HISTORIC AND DESIGN REVIEW COMMISSION

September 15, 2021

HDRC CASE NO: 2021-441
ADDRESS: 1003 NOLAN ST
LEGAL DESCRIPTION: NCB 1660 BLK H LOT S 152 FT OF 9
ZONING: R-6, H
CITY COUNCIL DIST.: 2
DISTRICT: Dignowity Hill Historic District
APPLICANT: Grace Villa /PATRICK GRACE KEEGAN
OWNER: Grace Villa /PATRICK GRACE KEEGAN
TYPE OF WORK: Installation of a driveway and parking pad in side and rear yard
APPLICATION RECEIVED: August 26, 2021
60-DAY REVIEW: Not applicable due to City Council Emergency Orders
CASE MANAGER: Edward Hall

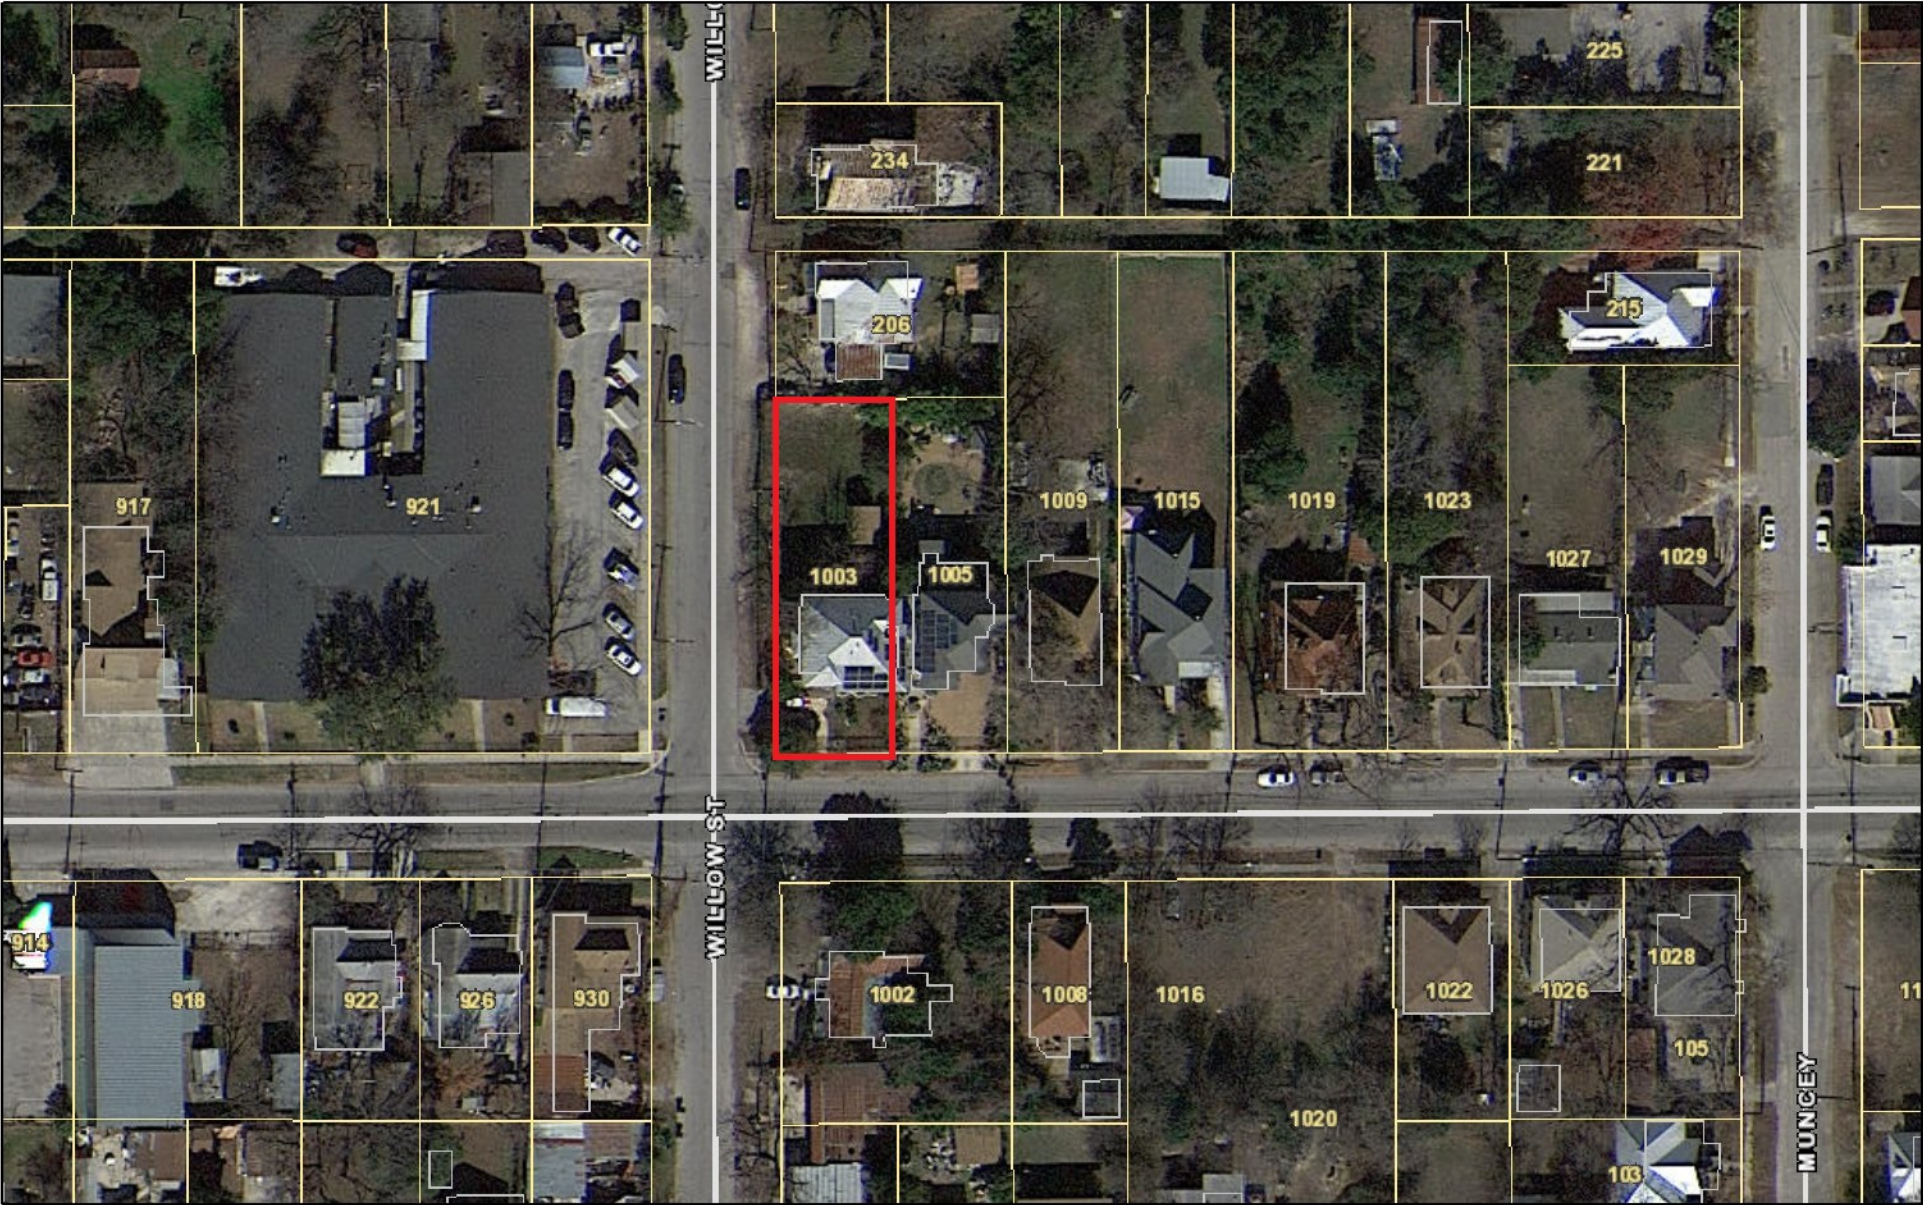
- c. DRIVEWAY AND CURB CUT – The applicant has proposed a driveway and curb cut to be located off Willow Street to provide vehicular access into the rear of the lot. The proposed driveway and curb cut widths are twenty (20) feet with the driveway featuring permeable stone pavers. The curb cut currently exists at this width. Staff finds the rear yard driveway and materials to be appropriate.

- d. PARKING PAD – The applicant has proposed a rear yard parking pad to feature approximately 400 square feet of concrete. Per the Guidelines for Site Elements 3.B.i., large pavers, asphalt or other impervious surfaces should not be introduced where they are not historically located. Staff finds the proposed rear parking pad to be inconsistent with the Guidelines.

1. Staff recommends approval of item #1, the relocation of the existing driveway. An impervious material such as gravel or decomposed granite is also appropriate.
2. Staff recommends approval of item #2, the installation of a rear yard parking pad with the following stipulations:
 - i. That the proposed parking pad be reduced in size, as noted in finding d.
 - ii. That the proposed parking pad feature pervious paving materials, such as gravel or decomposed granite.
